SEWAGE DISPOSAL SYSTEM

HOWARD COUNTY HEALTH DEPARTMENT

PROPERTY OWNER Dr. Ernest Colvin
ADDRESS 6398 Shady Lane

REPAIR - PURPOSE - ESTABLISH SEWAGE EASEMENT FOR FARM TRAILER. 12/14/92

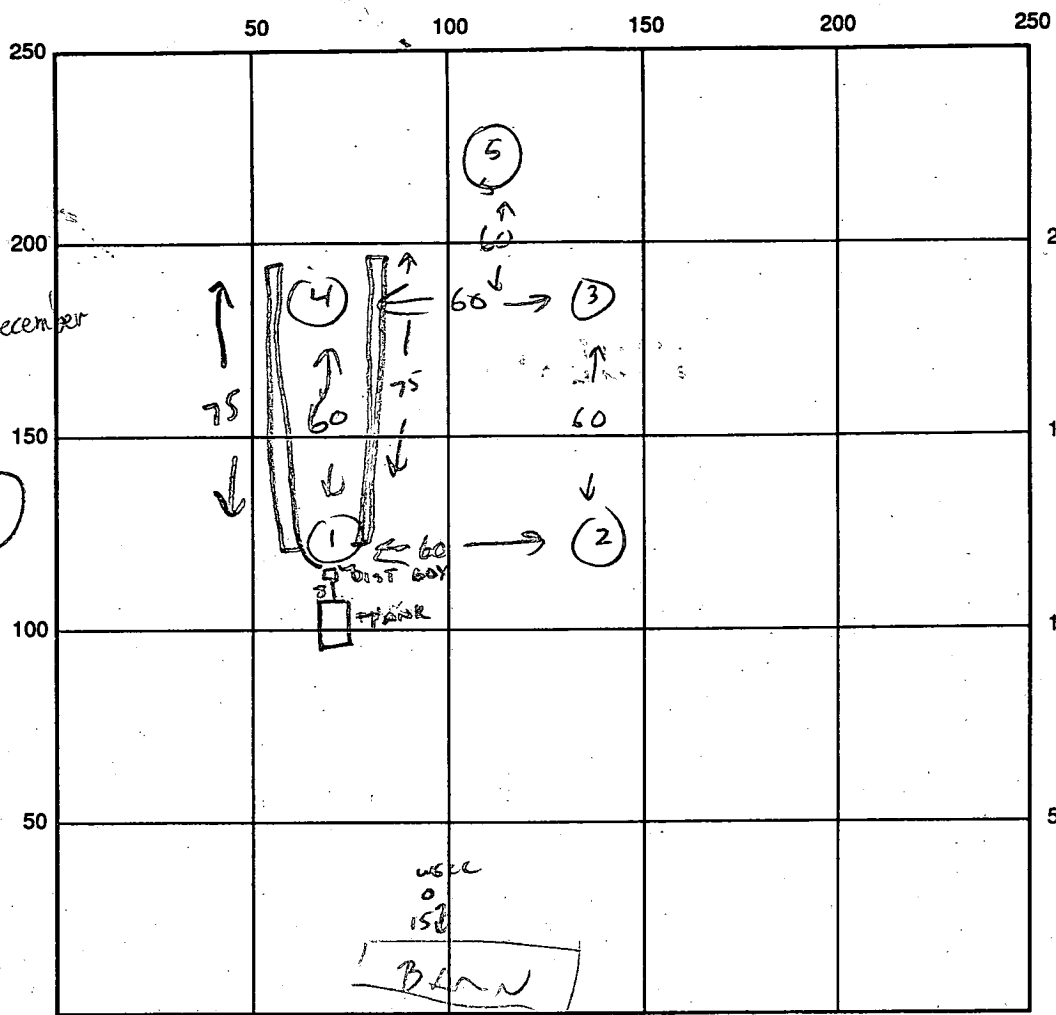
REMARKS: 12/15/92 5 TEST HOLES OK. WGL LINE BEING DUG TO CONNECT TO PRESSURE TANK IN BARN.

12/18 TRENCHES OK TO ADD STONE. 12/21 TRENCHES OK TO COVER.

NEEDS S.T. CLEANOUT & HOUSE SEWER LINE.

11/29/93 No answer @ trailer - appears all hooked up. all covered
